Ventura Unified School District Ventura High School Modernization

DRAWING TITLE:
BUILDING "T" EXISTING
ROOF FRAMING PLAN

AS REVISED BY CHANGE ORDER #19
APPROVED WORK IN THIS CHANGE
ORDER SHOWN HIGHLIGHTED
YELLOW.

DETAILS

EXISTING ROOF FRAMING PLAN - BLDG. "T"
SCALE: 1/8"=1'-0"

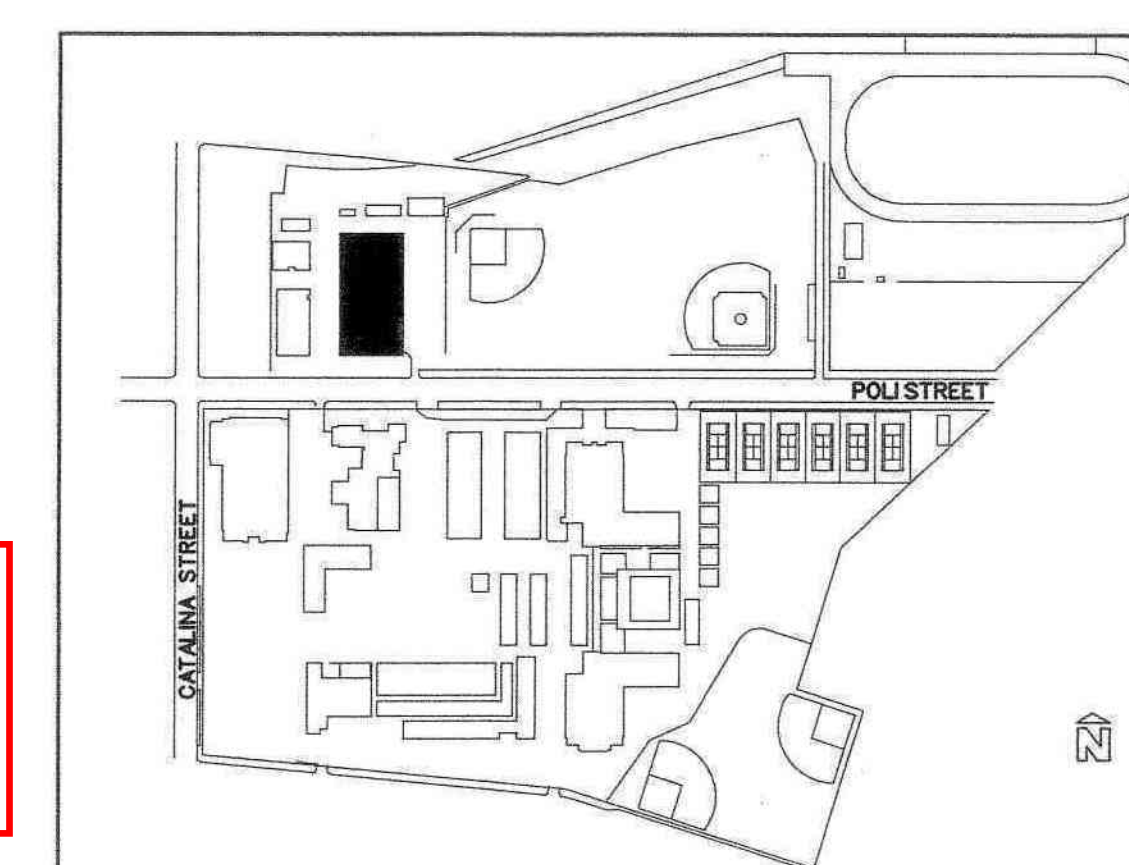
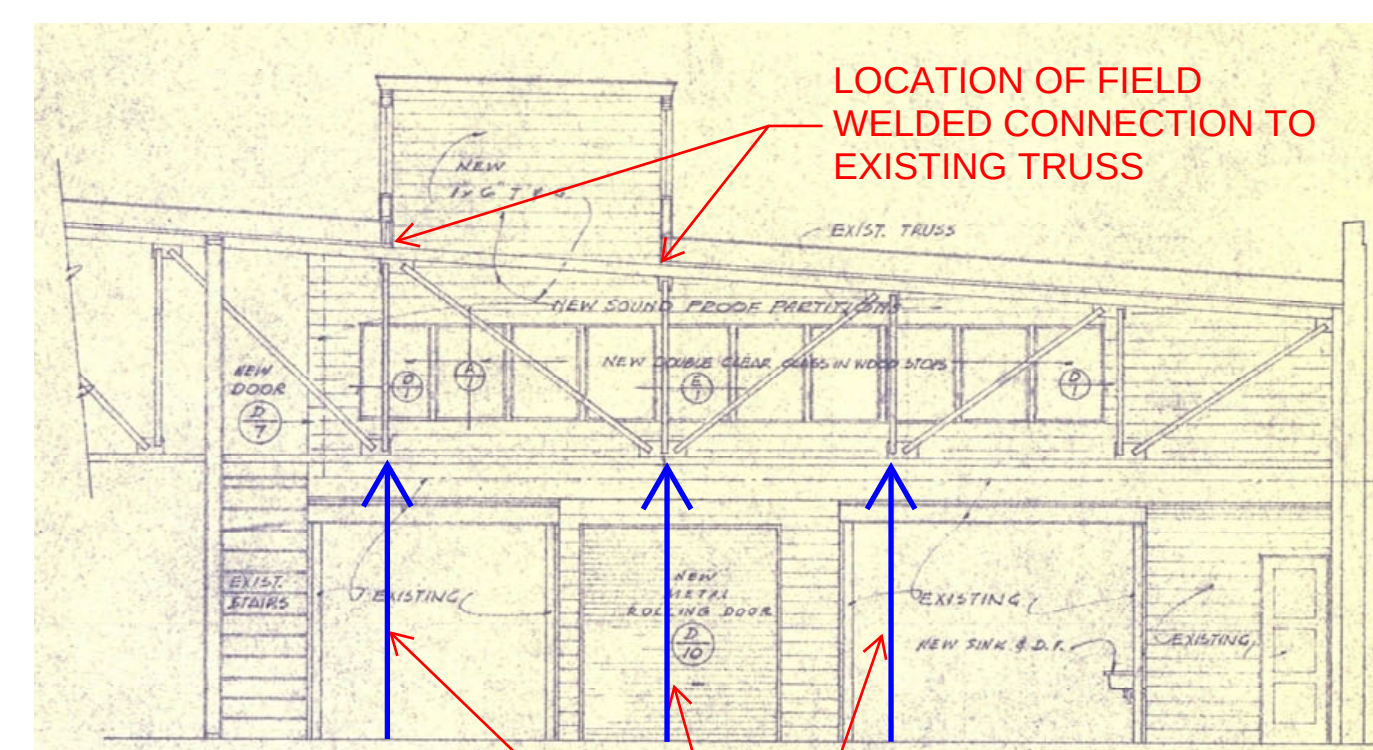
TEMPORARY SHORING BY CONTRACTOR
REQUIRED AT TRUSSES WHILE WELDING:

3 SHORING LOCATIONS EACH TRUSS. SHORING RESISTS FURTHER DEFLECTION DUE TO HEAT OF WELDING. 4,000 LB MINIMUM SHORING ASSEMBLY CAPACITY EACH SHORING POINT.

A2 PARTIAL DEMOLITION FROM BELOW
REF. SCALE: 3" = 1'-0"

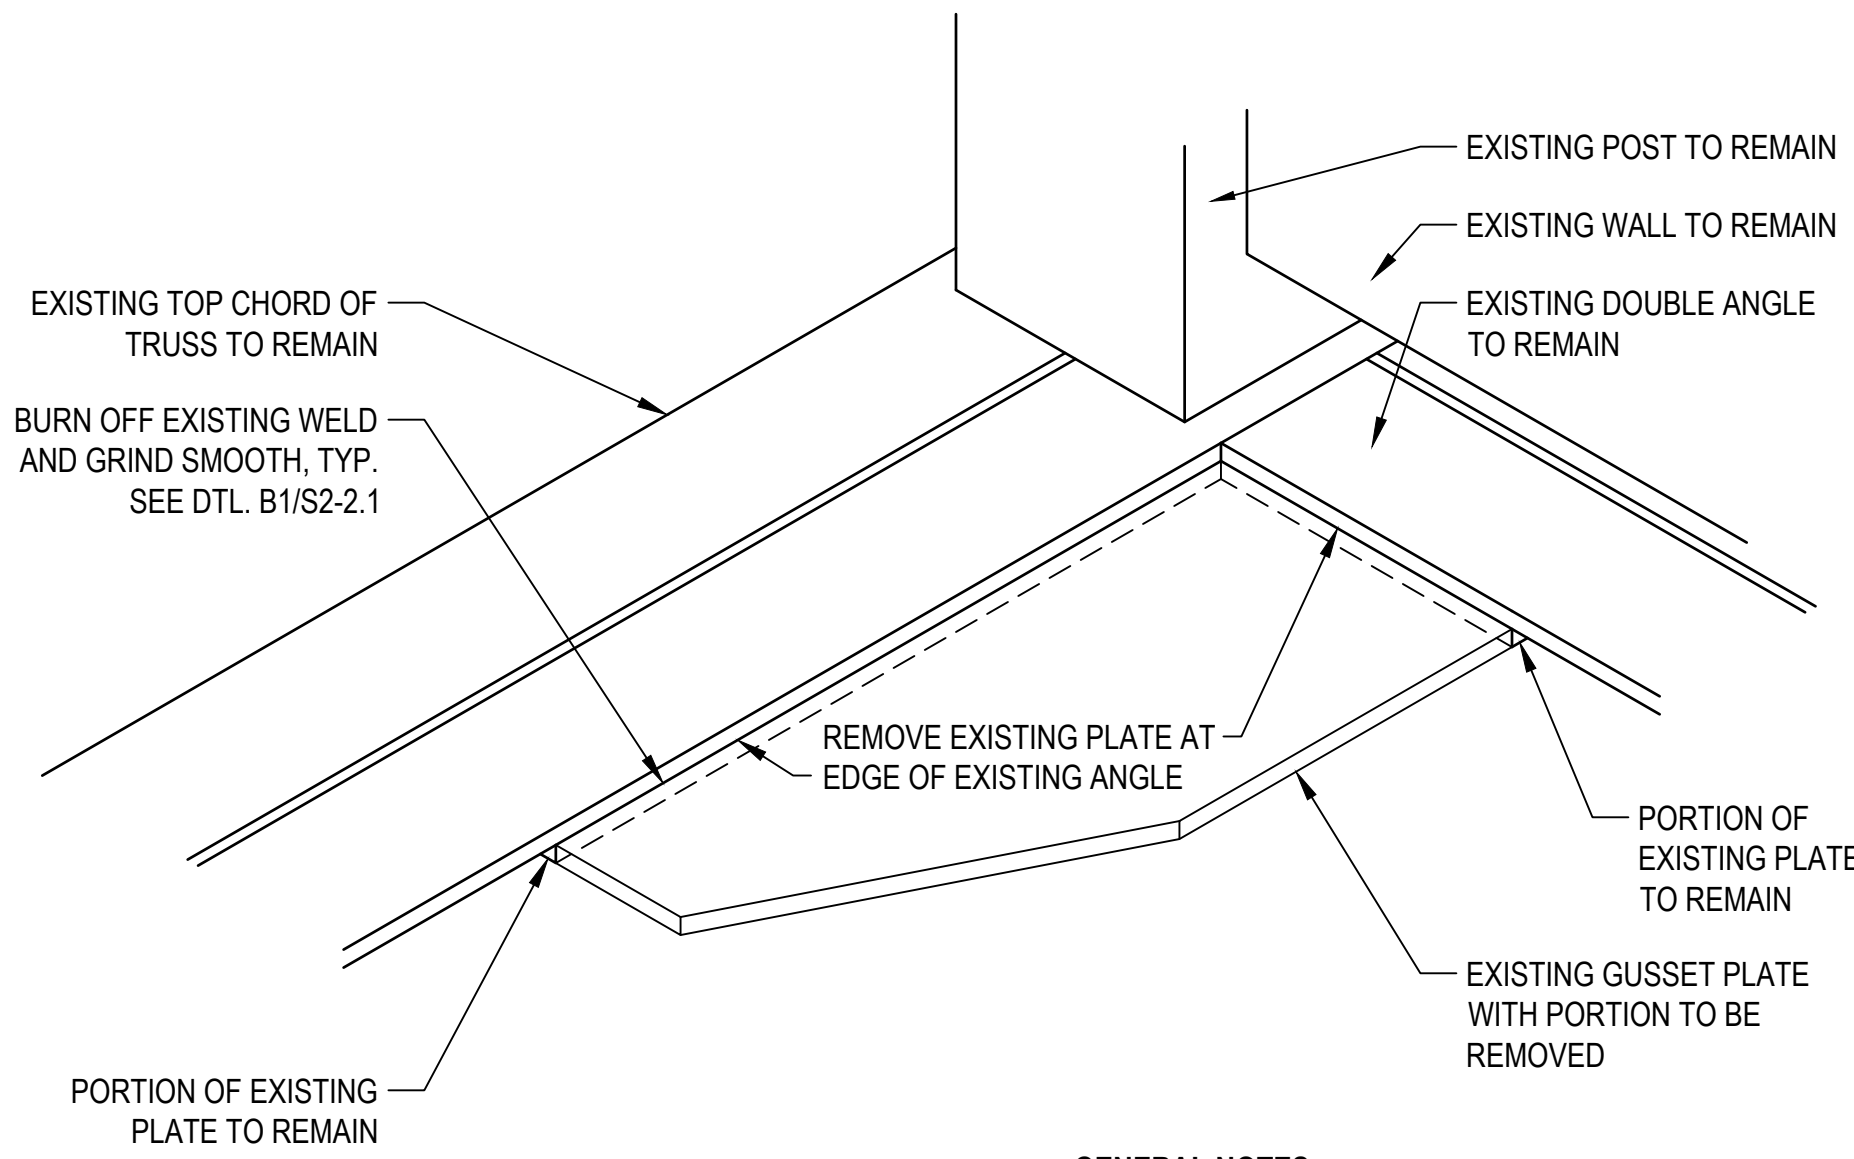
- GENERAL NOTES**
1. EXISTING CROSS BRACE NOT SHOWN FOR CLARITY - CROSS BRACE TO BE REMOVED
 2. SEE NEW DTL. A/S2-2.1 & A1/S2-2.1 FOR ADDITIONAL INFO NOT SHOWN HERE

A1 PARTIAL DEMOLITION
REF. SCALE: 3" = 1'-0"

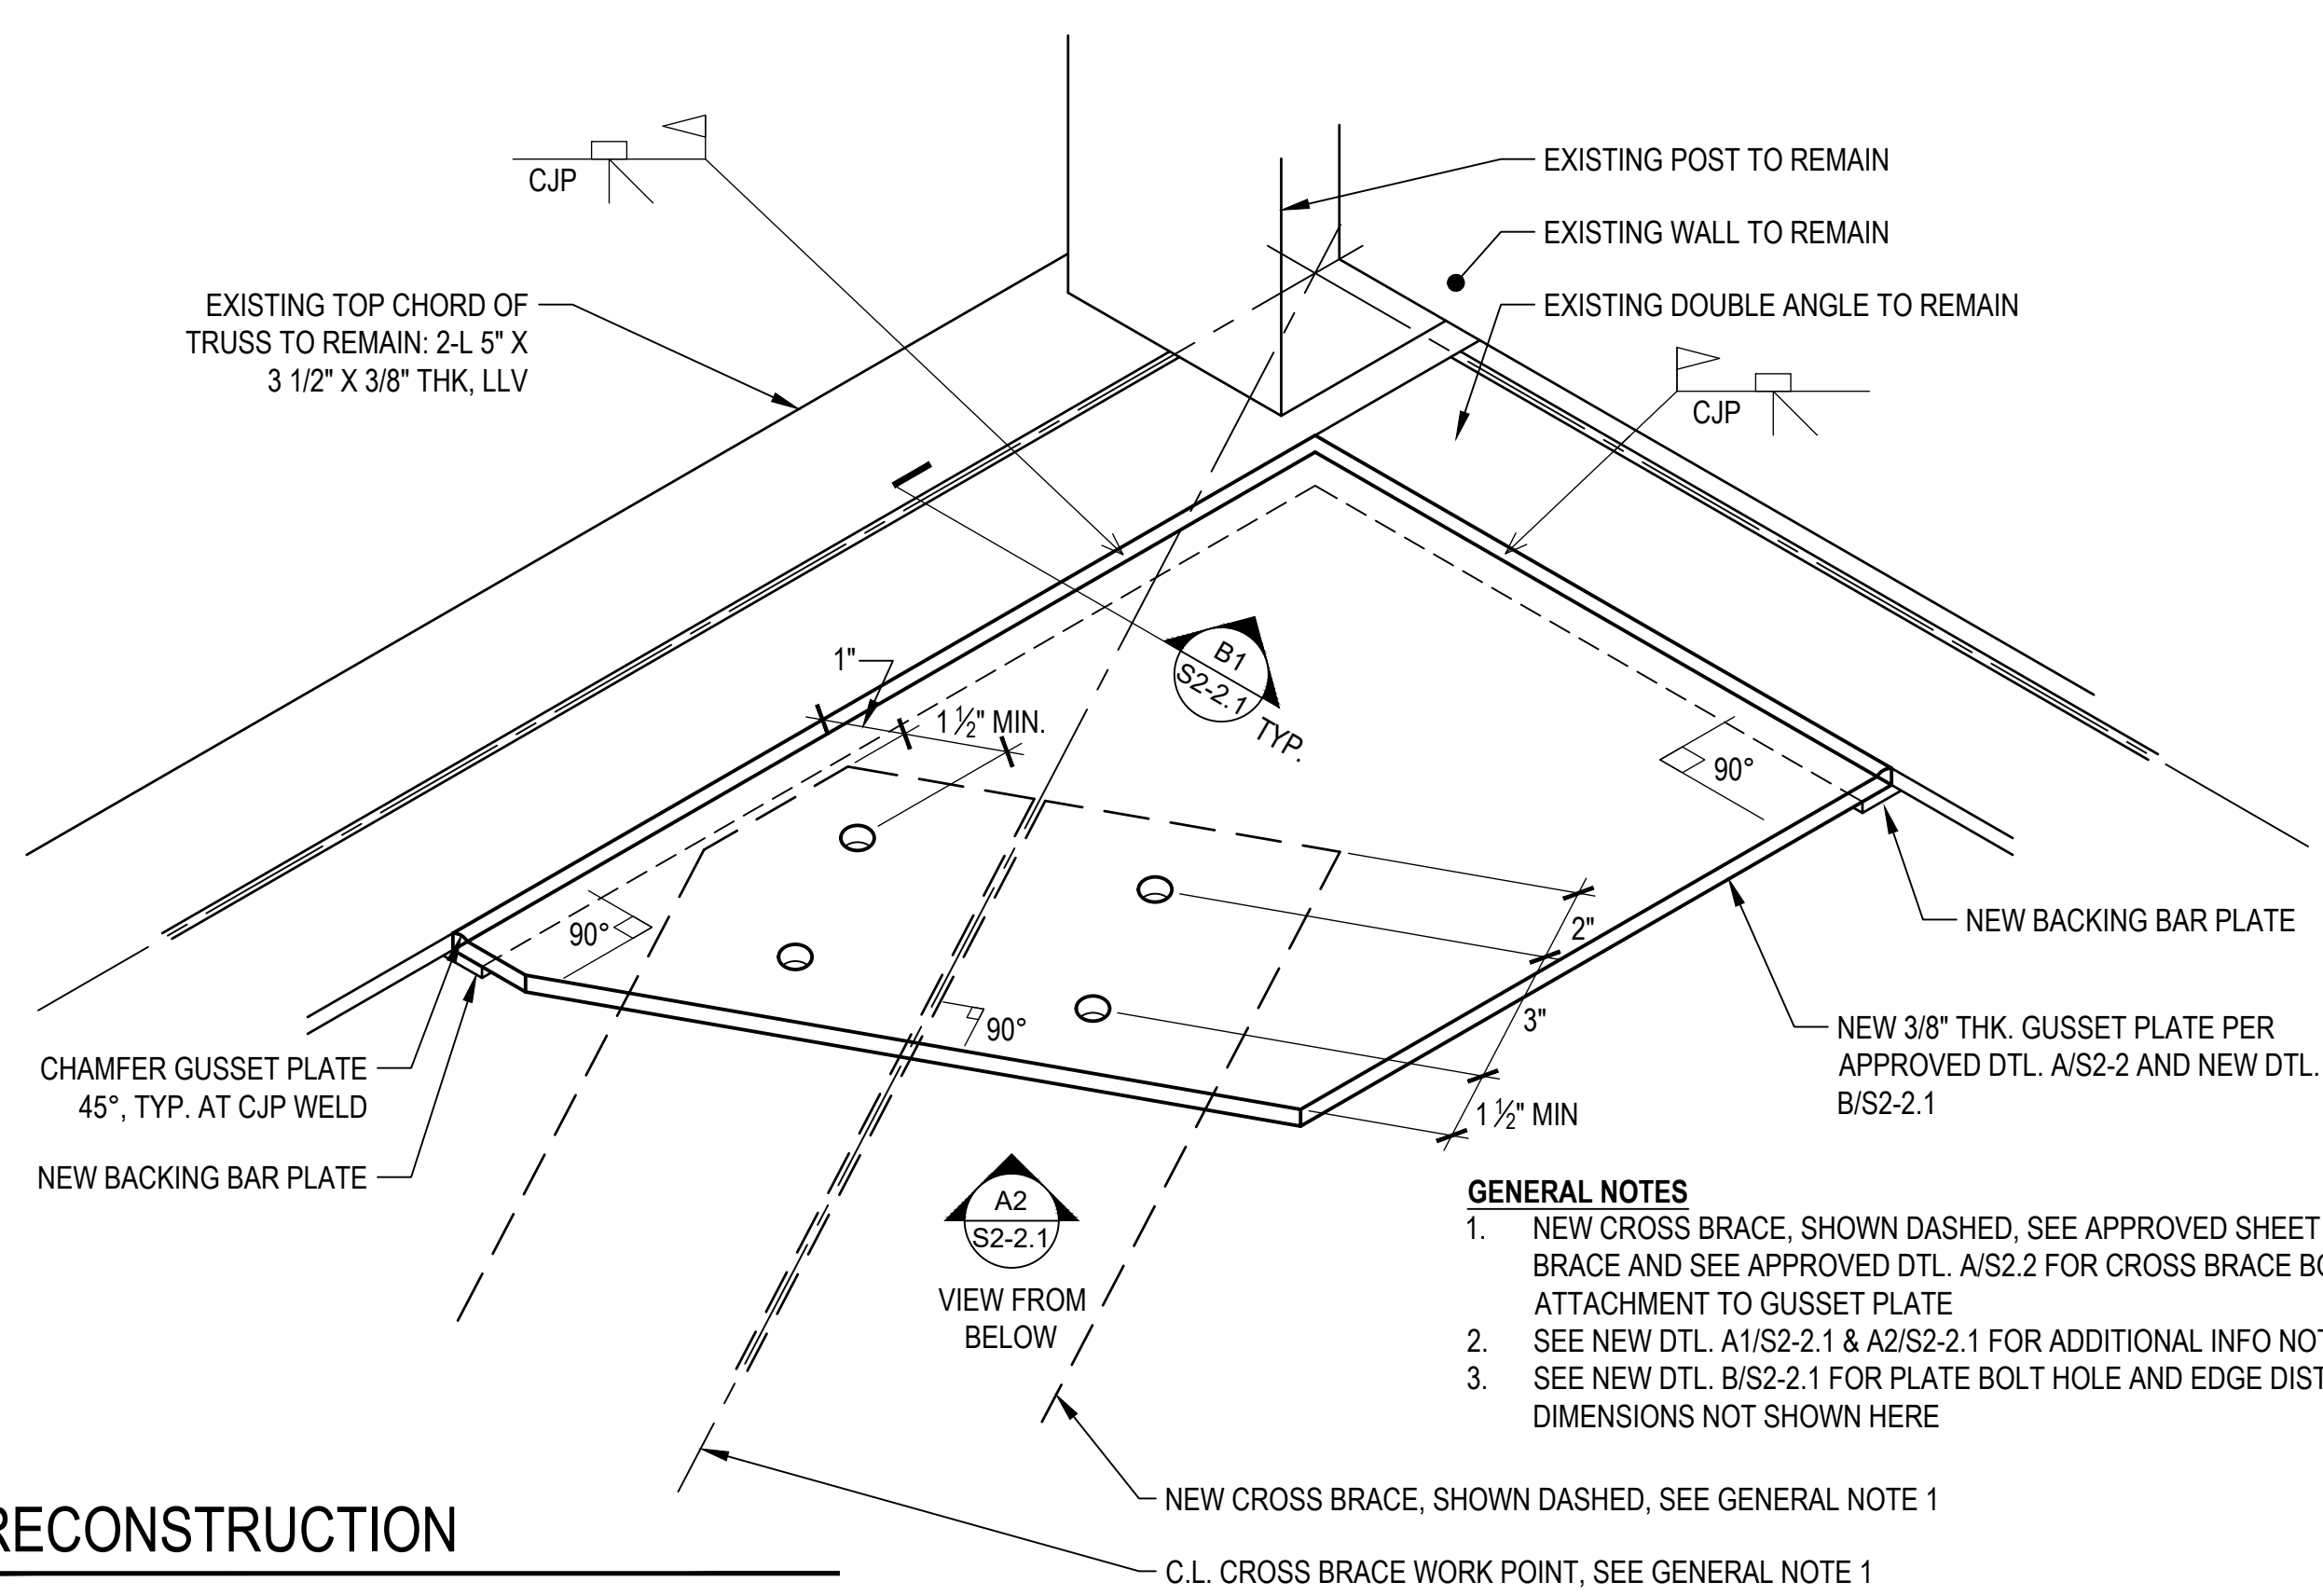
- GENERAL NOTES**
1. EXISTING CROSS BRACE NOT SHOWN FOR CLARITY - CROSS BRACE TO BE REMOVED
 2. SEE NEW DTL. A/S2-2.1 & A2/S2-2.1 FOR ADDITIONAL INFO NOT SHOWN HERE

A RECONSTRUCTION
REF. SCALE: 3" = 1'-0"

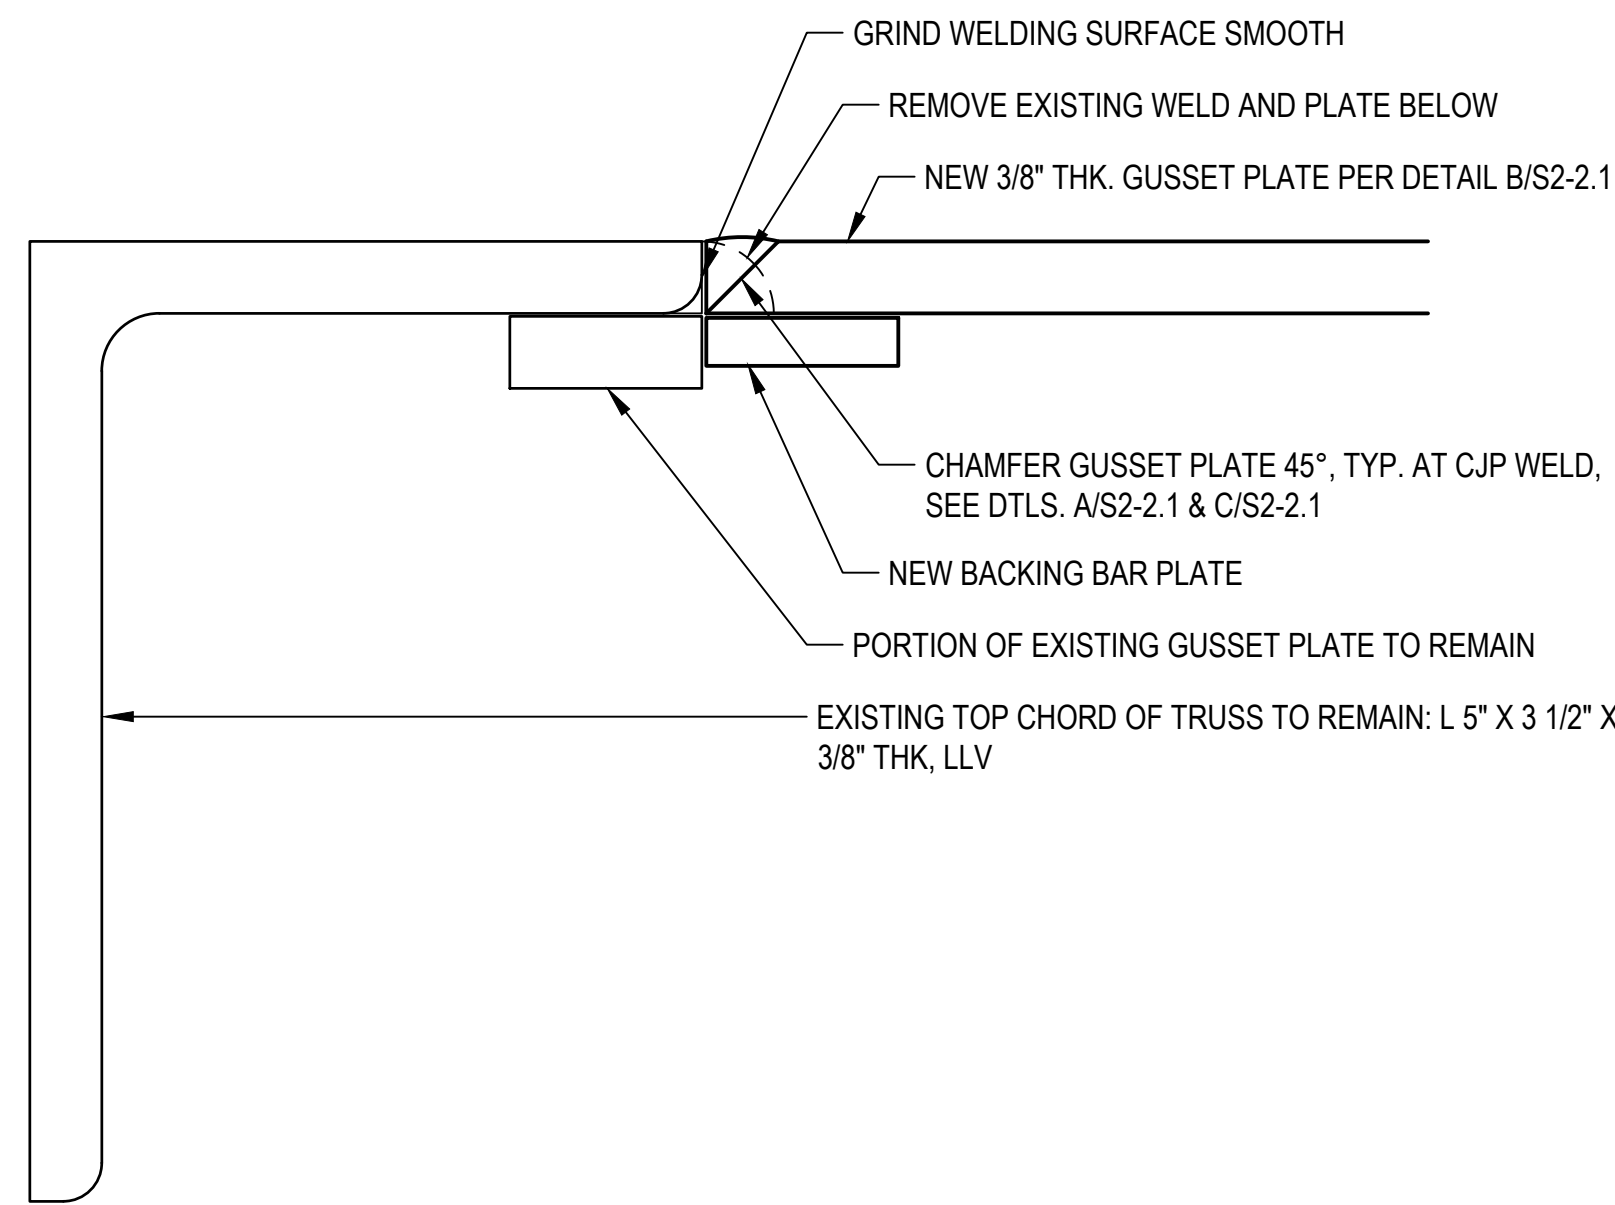
- GENERAL NOTES**
1. NEW CROSS BRACE, SHOWN DASHED, SEE APPROVED SHEET ST-1 FOR CROSS BRACE AND SEE APPROVED DTL. A/S2.2 FOR CROSS BRACE BOLTED ATTACHMENT TO GUSSET PLATE
 2. SEE NEW DTL. A1/S2-2.1 & A2/S2-2.1 FOR ADDITIONAL INFO NOT SHOWN HERE
 3. SEE NEW DTL. B/S2-2.1 FOR PLATE BOLT HOLE AND EDGE DISTANCE DIMENSIONS NOT SHOWN HERE
